DEVELOPMENT PLAN

Re: Development Plan Review: 145 W Pearl Ave, Jackson, Wy; 65 S Glenwood St, Jackson, Wy

Responses to Sketch Plan Review Comments (6.18.2025)

2 2ND FLOOR - COLOR PLAN
1/16" = 1'-0"

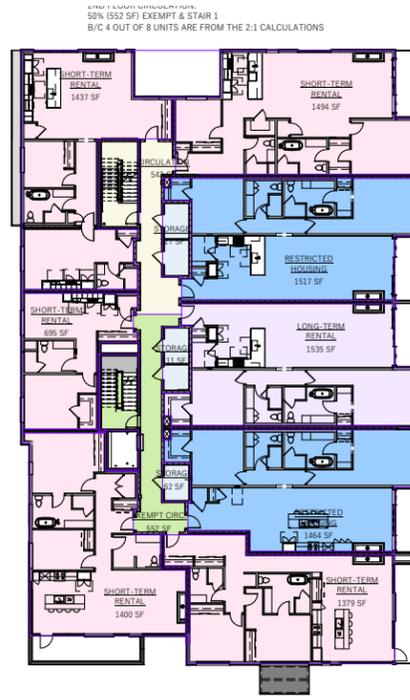
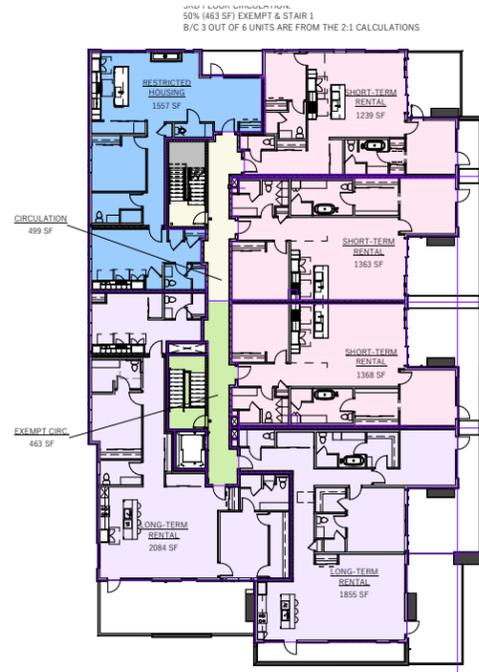
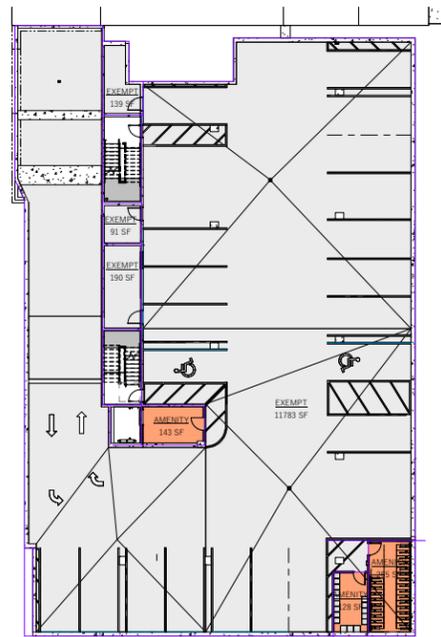
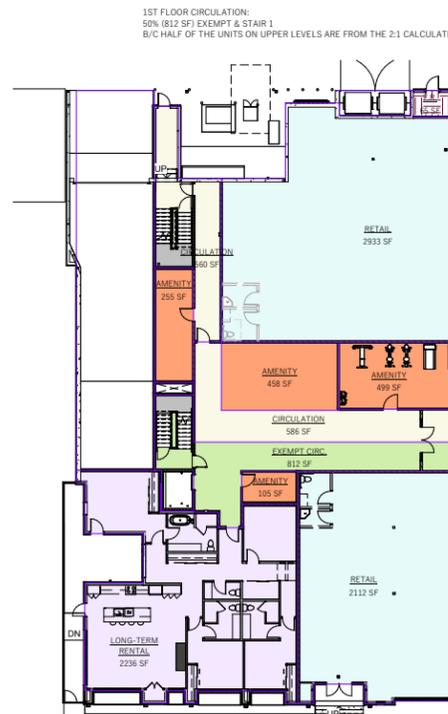
2. The 2:1 floor area numbers need to be clear and shown on the plans.

Responses: The Restricted Housing area is shown in blue on the FAR Color Plans, and the square footages of 5,653 SF is provided in the Area Breakdown. The 2:1 Bonus is calculated by taking the restricted housing area and multiplying it by 2 for a total of 11,306 SF. See sheet G120.

EXHIBIT A - PROP. LINE ENCROACHMENT PLAN - GLENWOOD
1/8" = 1'-0"

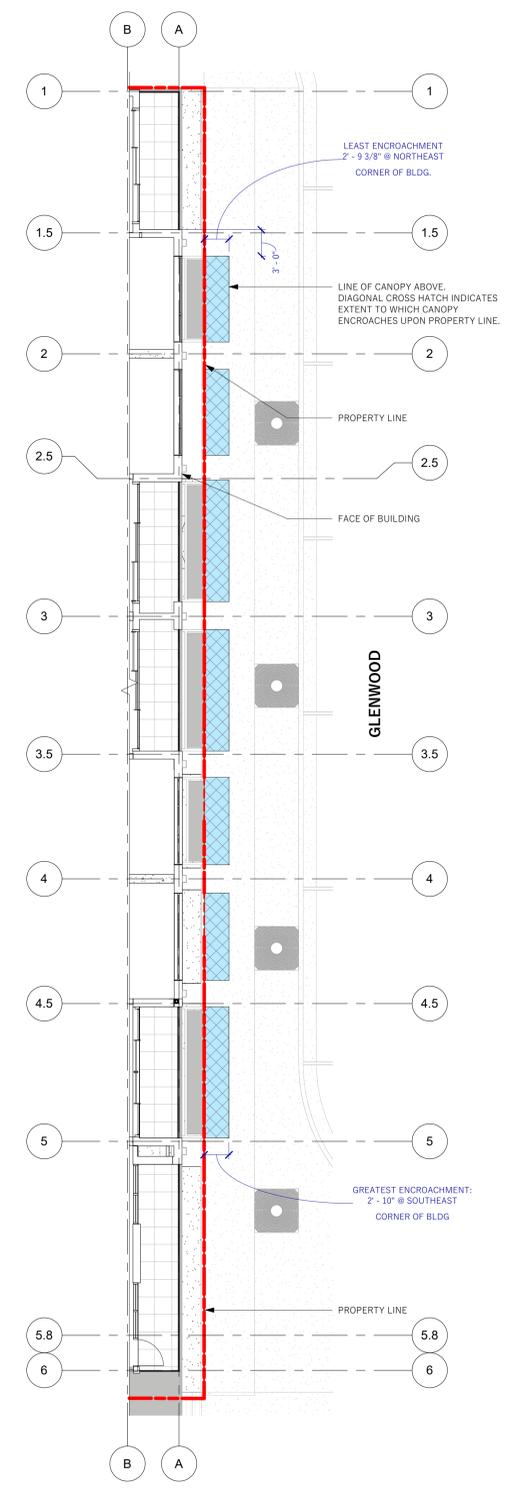
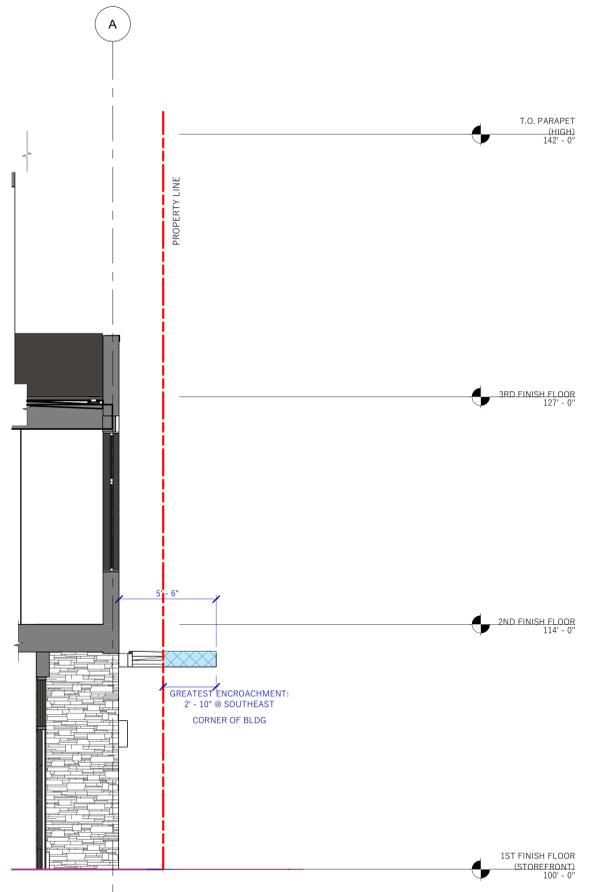
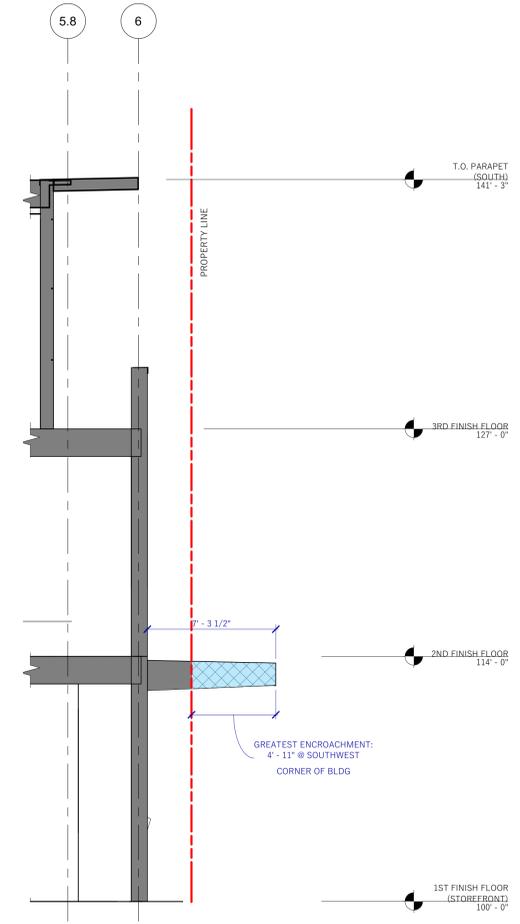
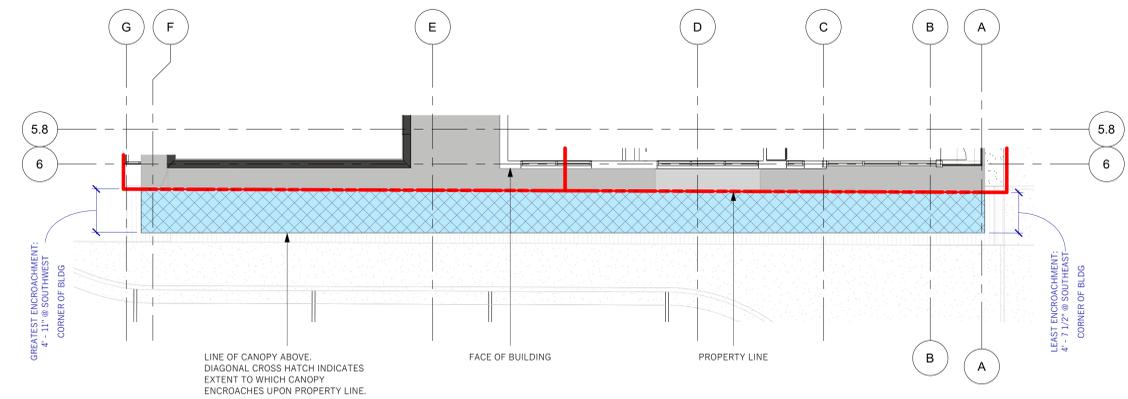
23. Show all encroachments into the Towns right-of-way or easements. Encroachment agreements are required for encroachments of buildings, retaining walls, foundations, canopies, balconies, roofs, shoring, etc. Minimize encroachments to those required by the LDRs. Nested awning above the covered sidewalk will be considered.

SITE DEMOLITION

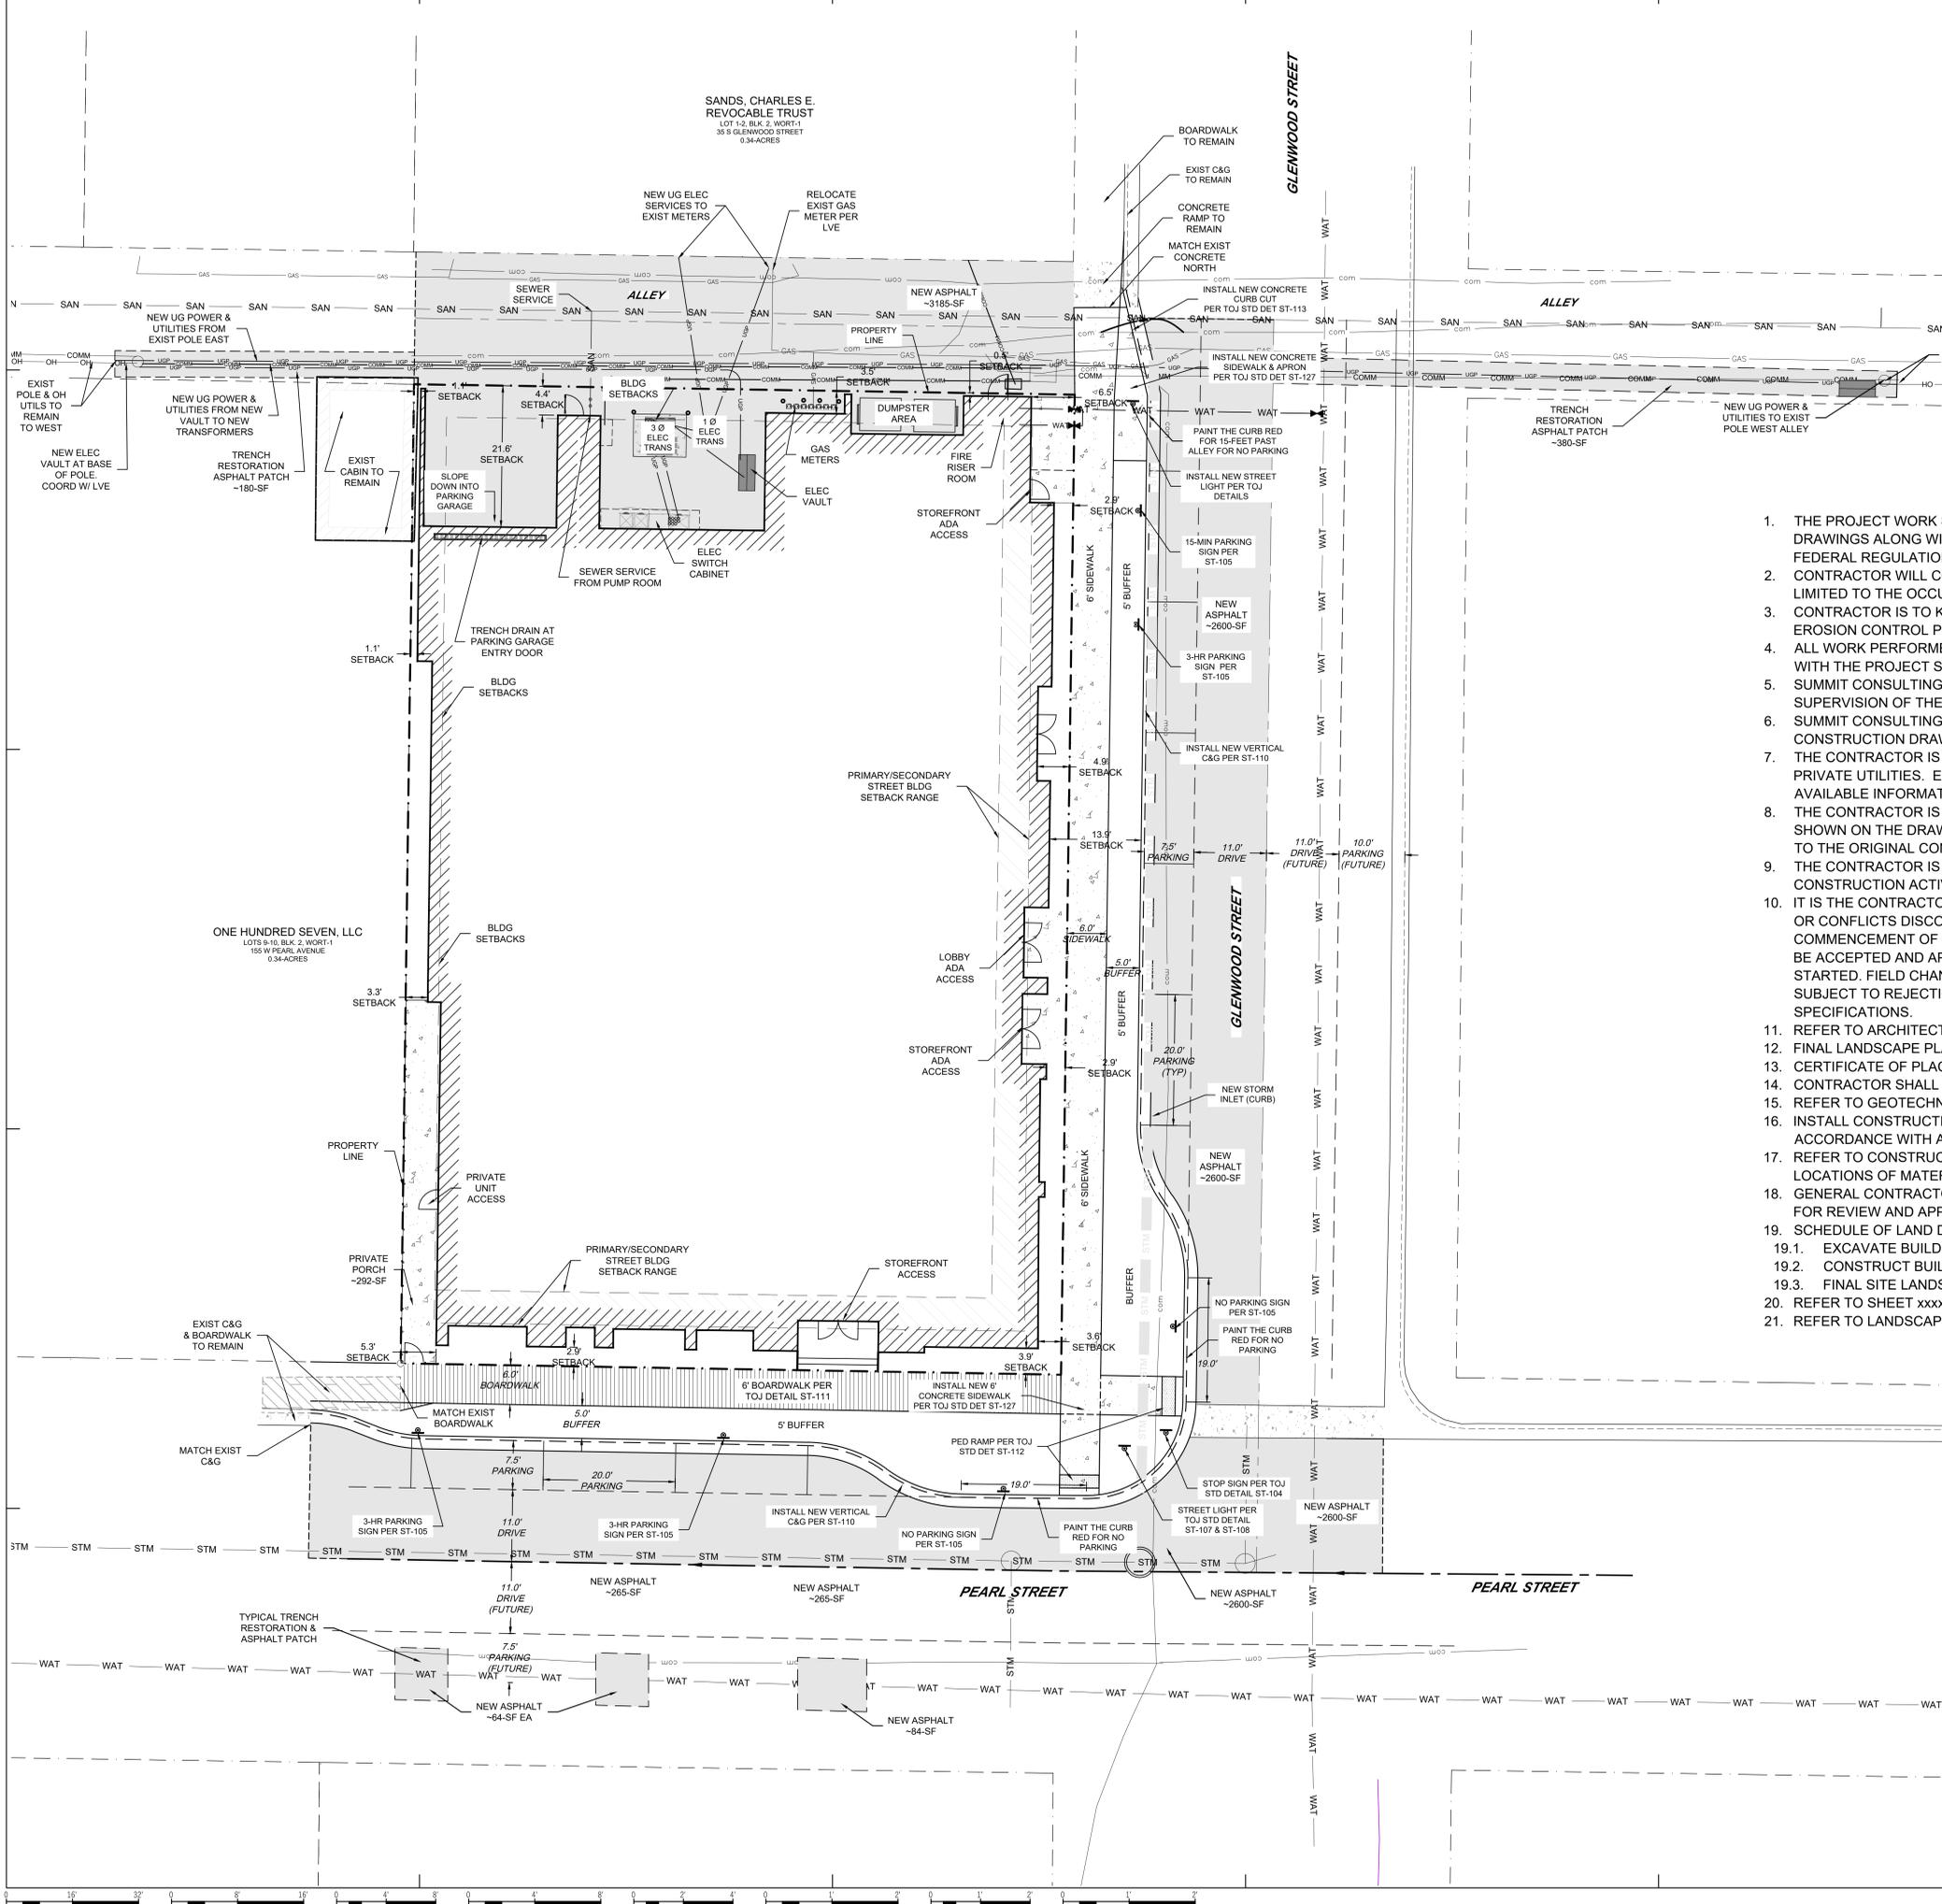
5. Show existing utilities to be abandoned at the main.

PROPOSED UPPER LEVEL GRADING PLAN

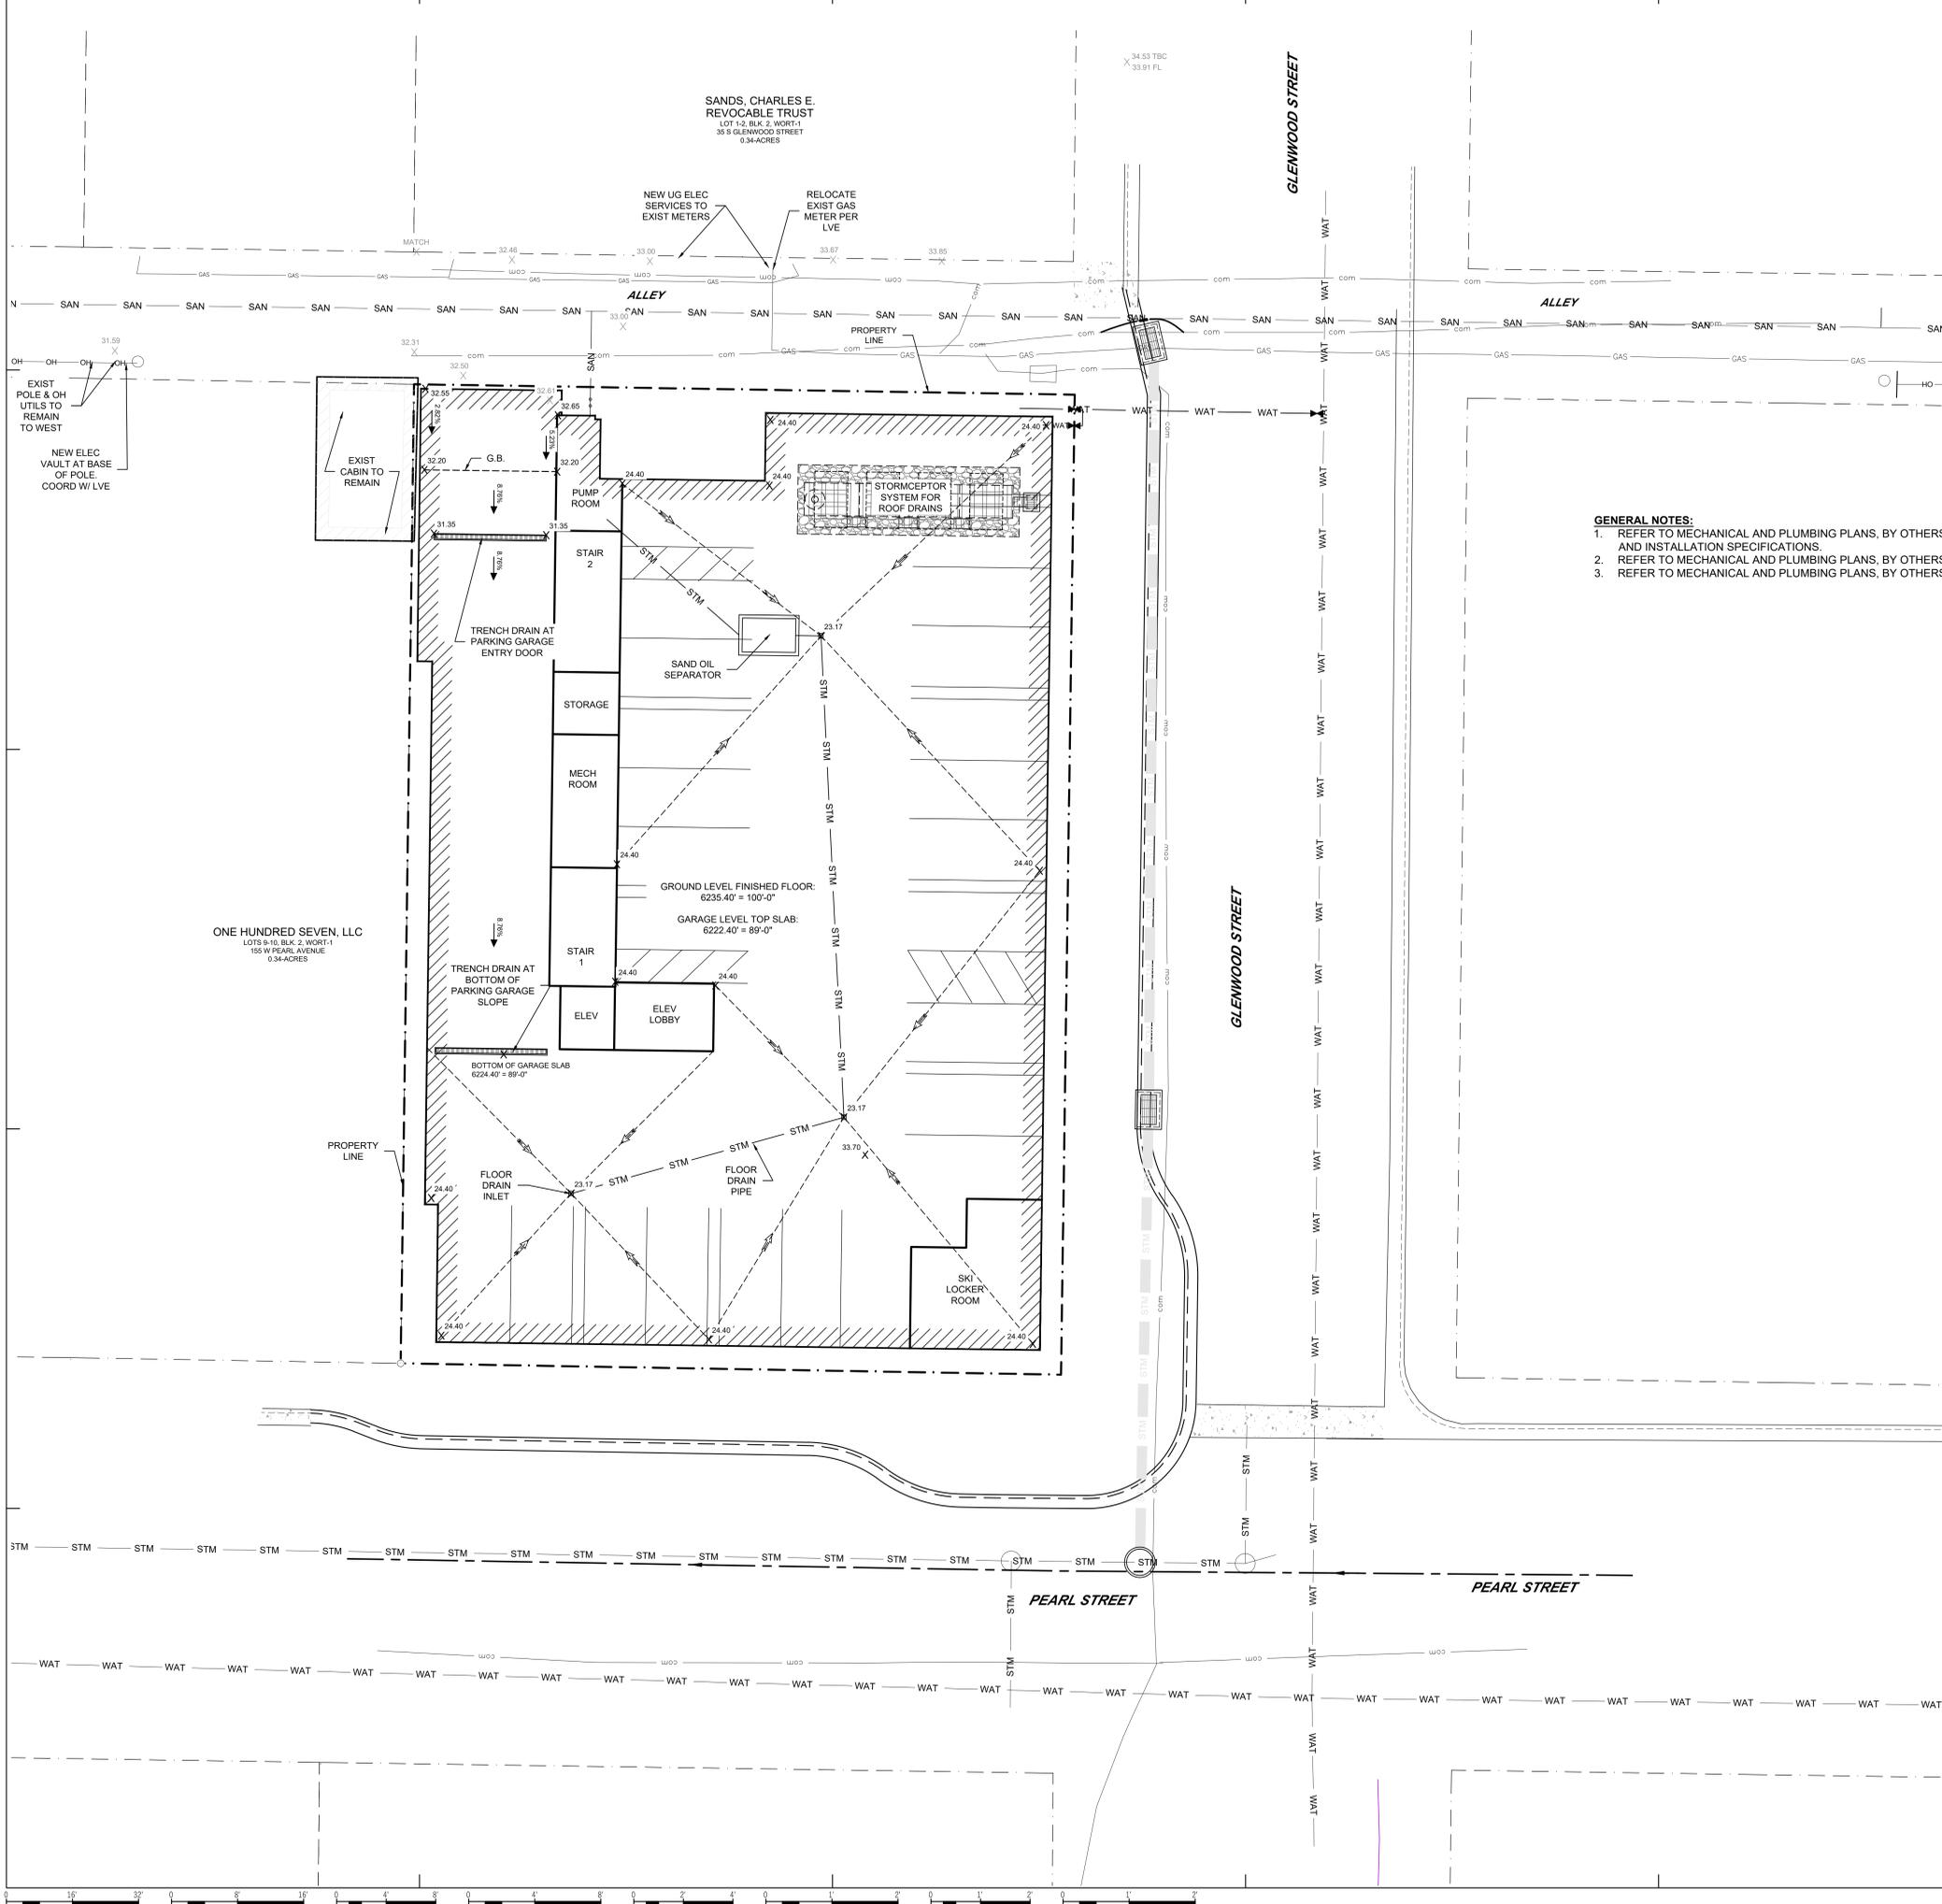
11. Provide conceptual grading plans showing running slopes and cross slopes of sidewalks, identify accessible routes, and parking areas, snow storage, and surface drainage slopes.

Responses: Grading plan (draft) provided. No grading proposed on adjacent properties.
